2500 Wilson Blvd.

LITTLE
 DIVERSIFIED ARCHITECTURAL CONSULTING

CENTURY

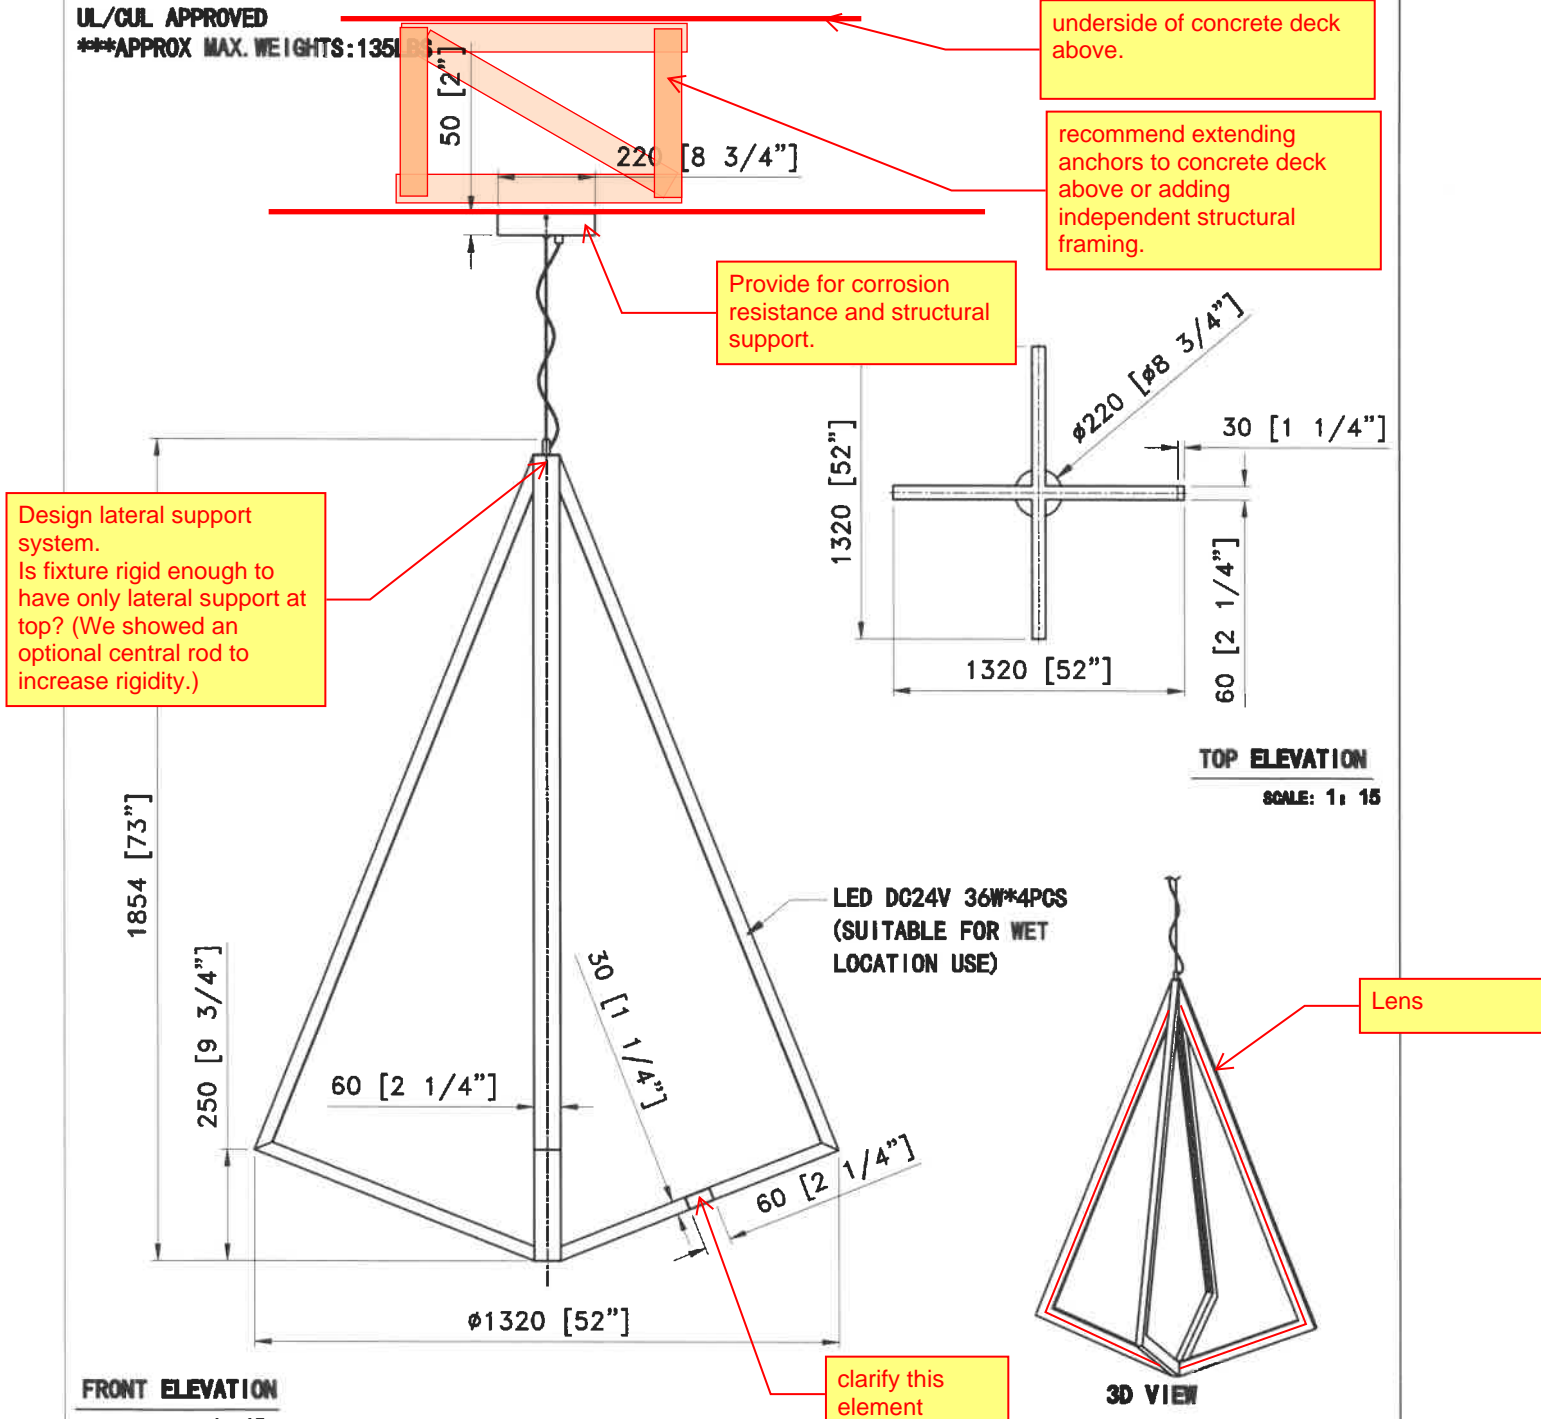
1. See 1/A623 for design intent and requirements.
2. Submit anchorage details, fixture weights, and lateral bracing. Metals are designed as aluminum to reduce corrosion and weight. The weights listed in the documents were requested by the AHJ. The design will need to demonstrate structural support and weights for the AHJ to approve. Changes to other metals needs to account for corrosion prevention.

3. Submit section details of light source, housing and lens. The lens is intended to wrap the corners vs. being flat or one-sided.
4. ~~Match paint~~ Matte black OK. High performance coating most important. (D Stadler)

5. Upon resubmittal, the drawings will be reviewed by the electrical engineer. Additional comments may result.
6. Please provide 3000k light source. Submit lumen output information.

7. Submit lateral bracing details and connection points.
8. Note that suspension distances are long.
